PROGRAM INFORMATION BULLETIN NO. P07-15

SUBJECT: Potential Safety Hazard on Permissible Mobile Diesel-Powered
Transportation Equipment with Sandvik (formerly EJC Mining
Equipment, Inc.) Wet Scrubber Systems

Fatigue in Exhaust Conditioner Unit

Power System Checklist Addendum

Figure No. 2

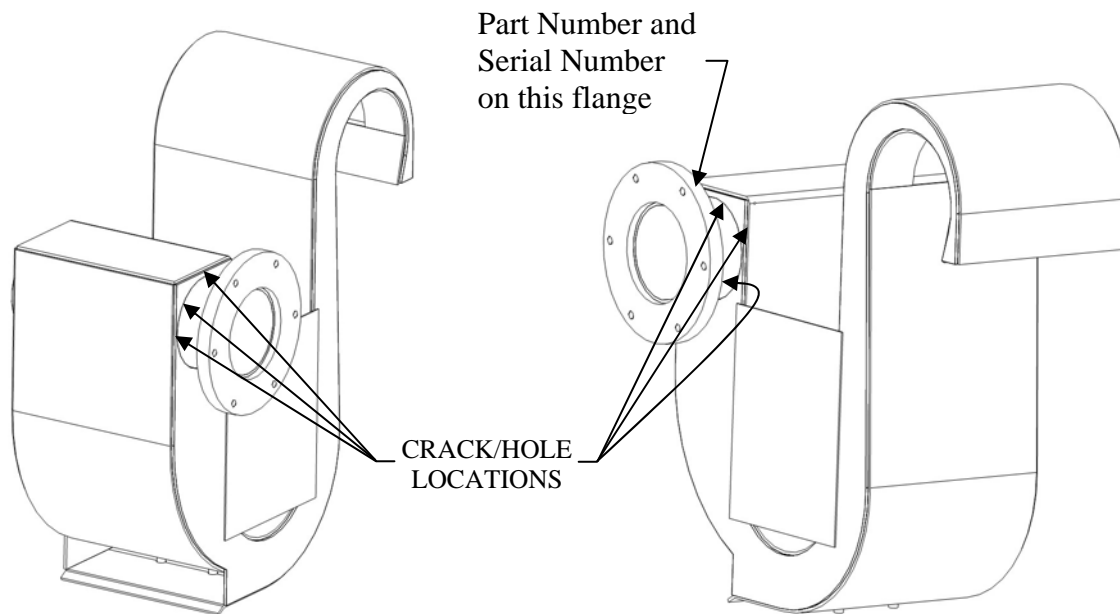
Figure No. 1 and Figure No. 2 below can be referenced for a general view of the wet scrubber insert and the location of the cracks/holes that have been found on inserts in the field.

Wet Scrubber Insert used on the following Equipment Approval Numbers: 31-121, 31-117, 31-217, 31-120, 31-124, 31-126, 31-128, 31-131, 31-132, 31-137, 31-203, 31-204, 31-205, 31-206, 31-216, 36C-002, 36C-004, 36C-008

located on the inlet flange of the insert as shown in Figure No. 1 and Figure No. 2 above.

Figure No. 1

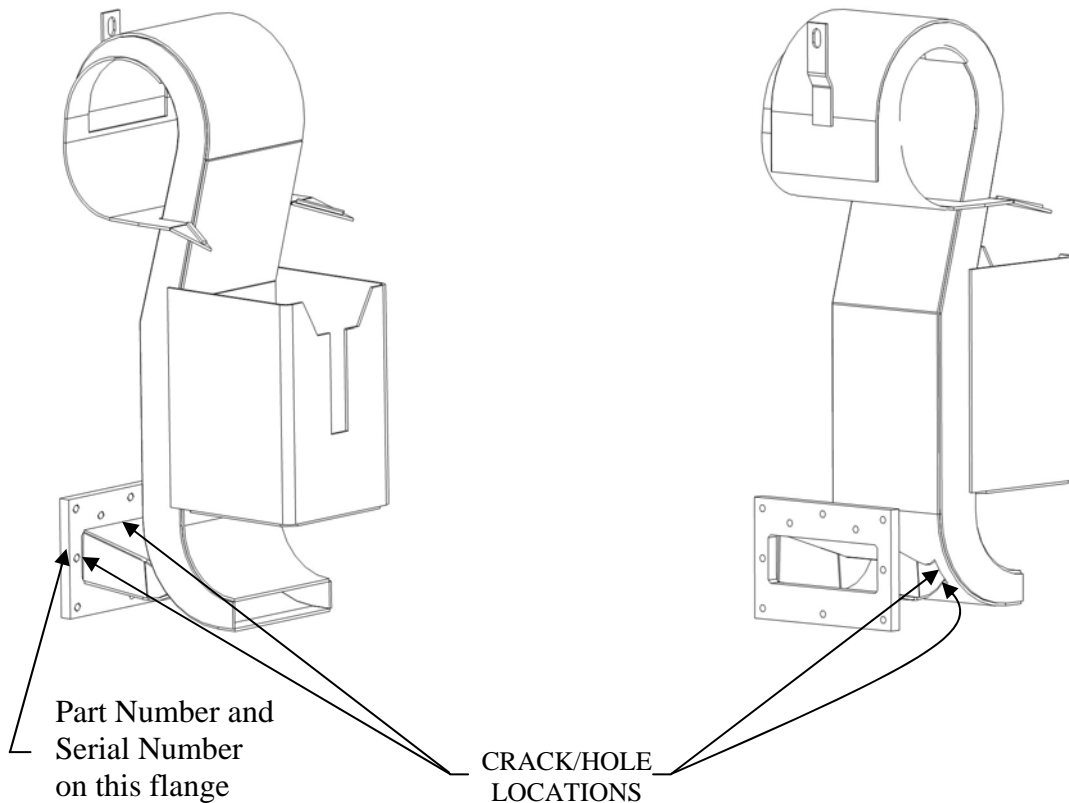
A weld bead crack failure may allow flames, sparks, or hot diesel engine exhaust gas to bypass the flame proofing, spark arresting, and engine exhaust gas cooling effects of the scrubber system and enter the mine atmosphere.

The scrubber system consists of an insert that is mounted inside an exhaust conditioner enclosure (tank partially filled with water). The crack failure developed in and near the inlet flange weld bead of the insert. Some of the weld bead cracks enlarged enough to produce a hole in the weld and surrounding material. The Sandvik wet scrubber system is used on permissible mobile diesel-powered transportation equipment to prevent propagation of flame or discharge of heated particles to the surrounding mine atmosphere and to cool the diesel engine exhaust gas at the discharge from the exhaust conditioner. The wet scrubber system is required to cool the diesel engine exhaust gas to a maximum of 170 degrees Fahrenheit per 30 C.F.R. §§ 7.98(s)(4)(i) and 36.25(c), and arrest spark and flame per 30 C.F.R. § 7.98(s)(2) and 30 C.F.R. § 36.25(b)(3).

Wet Scrubber Insert used on the following Equipment Approval Numbers: 31-103, 31-110, 31-125, 31-135, 31-202, 31-207, 31-208, 31-211, 31-228, 31-26-3, 36C-003, 36C-005, 36C-006

All permissible mobile diesel-powered transportation equipment with a Sandvik wet scrubber system must be inspected for weld failure in the wet scrubber insert. The insert inspection should be conducted during the next scheduled weekly maintenance examination. Inserts that are found defective must be replaced with an acceptable insert. Sandvik has issued a technical bulletin to inform their customers on the proper procedure to remove and inspect the wet scrubber insert. See Attachment to view Sandvik's technical bulletin.

Figure 2: Exhaust Conditioner Unit (Example)

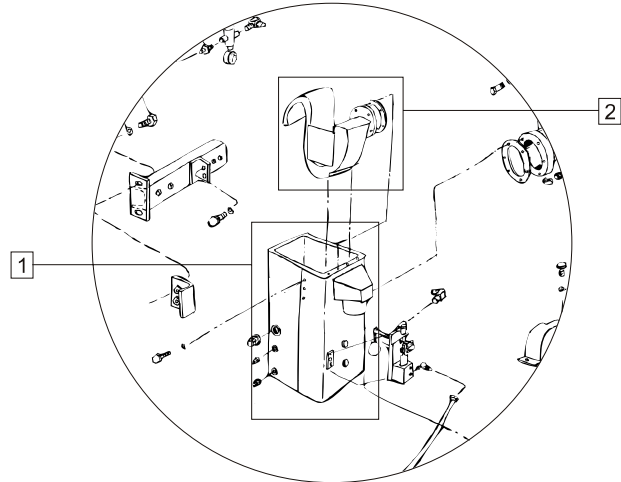
- 8) Remove the exhaust conditioner insert from the enclosure. Clean the unit thoroughly. Inspect the unit, including welds, for cracks or holes. Thoroughly inspect the unit visually and/or by using a non-destructive inspection method, such as a "crack check" or Liquid Penetrant Inspection (LPI).

The insert unit is defective if any cracks, holes, or other damage are detected. Contact your local Sandvik Mining and Construction regional office for more information on obtaining a replacement insert (refer to [Contact Information](#)).

When reassembling the exhaust conditioner insert and enclosure, ensure all bolts are made of stainless steel.

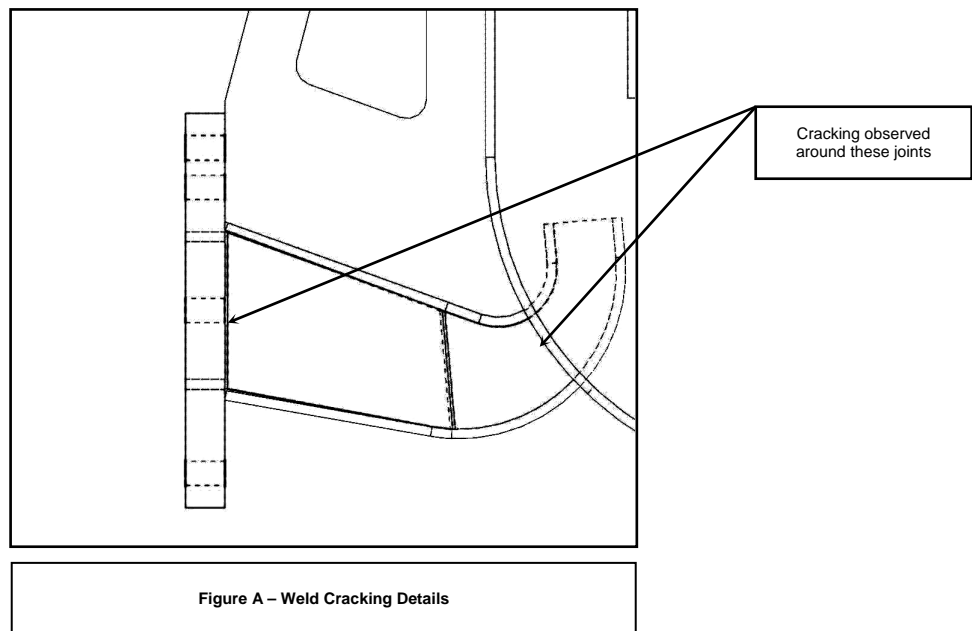
4. () Remove the Exhaust Conditioner Insert from the enclosure. Clean outside surface area of Insert for visual examination. Visually inspect the entire unit, including welds, for cracks, holes and other damage. A non-destructive inspection method such as “crack check” or Liquid Penetration Inspection (LPI) may be used to verify the condition of suspect areas. [See Figure A for shows the location of cracks/holes that have been found on inserts in the field.

5. () If any cracks, holes or other damage are detected, the Insert must be replaced with an Eimco Insert marked as shown in Figure B with reinforcement bracket and a part number and serial number prior to putting the machine back in service. If no cracks, holes or other damage are detected reinstall the Insert including internal copper flange gasket, any float system hardware and exhaust conditioner cover that was removed.

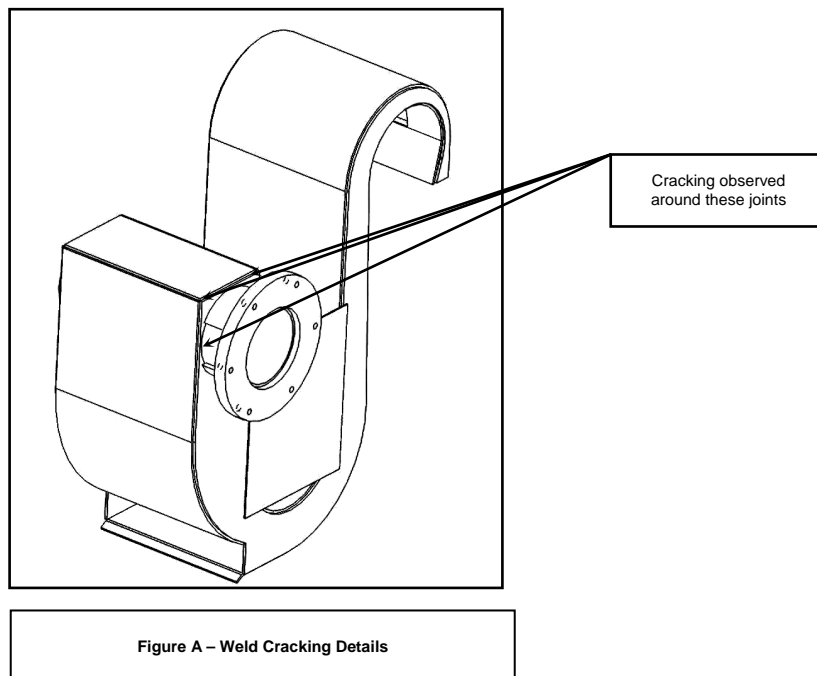
4. () Remove the Exhaust Conditioner Insert from the enclosure. Clean outside surface area of Insert for visual examination. Visually inspect the entire unit, including welds, for cracks, holes and other damage. A non-destructive inspection method such as “crack check” or Liquid Penetration Inspection (LPI) may be used to verify the condition of suspect areas. [See Figure A for shows the location of cracks/holes that have been found on inserts in the field.

5. () If any cracks, holes or other damage are detected, the Insert must be replaced with an Eimco Insert marked as shown in Figure B with reinforcement bracket and a part number and serial number prior to putting the machine back in service. If no cracks, holes or other damage are detected reinstall the Insert including internal copper flange gasket, any float system hardware and exhaust conditioner cover that was removed.

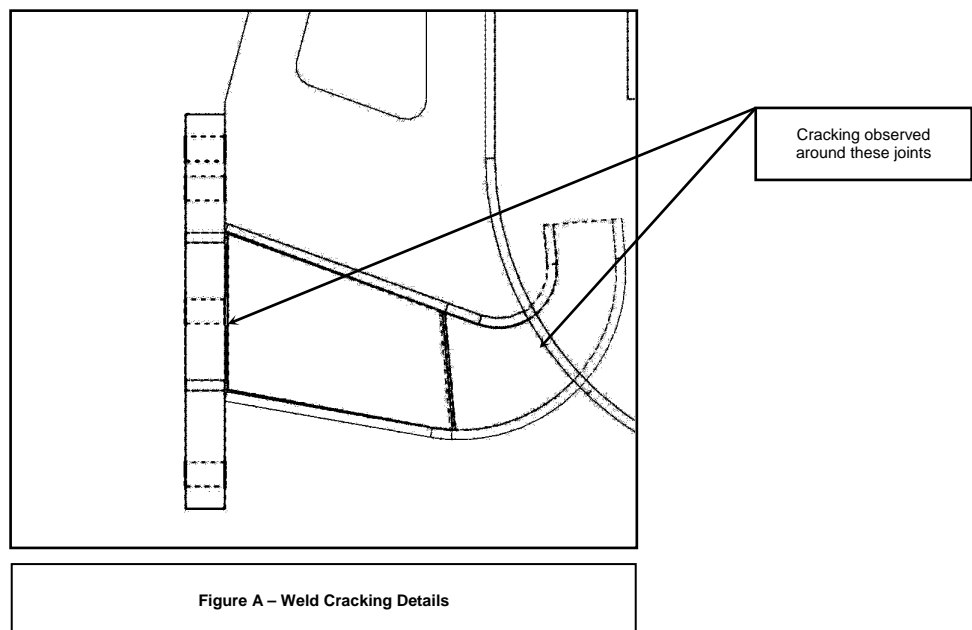
4. () Remove the Exhaust Conditioner Insert from the enclosure. Clean outside surface area of Insert for visual examination. Visually inspect the entire unit, including welds, for cracks, holes and other damage. A non-destructive inspection method such as “crack check” or Liquid Penetration Inspection (LPI) may be used to verify the condition of suspect areas. [See Figure A for shows the location of cracks/holes that have been found on inserts in the field.

5. () If any cracks, holes or other damage are detected, the Insert must be replaced with an Eimco Insert marked as shown in Figure B with reinforcement bracket and a part number and serial number prior to putting the machine back in service. If no cracks, holes or other damage are detected reinstall the Insert including internal copper flange gasket, any float system hardware and exhaust conditioner cover that was removed.

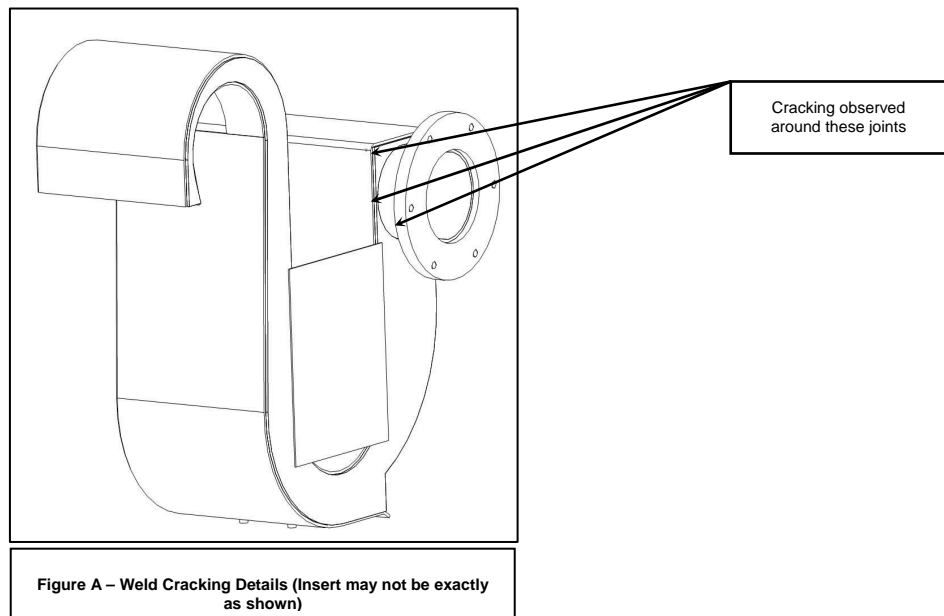
4. () Remove the Exhaust Conditioner Insert from the enclosure. Clean outside surface area of Insert for visual examination. Visually inspect the entire unit, including welds, for cracks, holes and other damage. A non-destructive inspection method such as “crack check” or Liquid Penetration Inspection (LPI) may be used to verify the condition of suspect areas. [See Figure A for shows the location of cracks/holes that have been found on inserts in the field.

5. () If any cracks, holes or other damage are detected, the Insert must be replaced with an Eimco Insert marked as shown in Figure B with reinforcement bracket and a part number and serial number prior to putting the machine back in service. If no cracks, holes or other damage are detected reinstall the Insert including internal copper flange gasket, any float system hardware and exhaust conditioner cover that was removed.
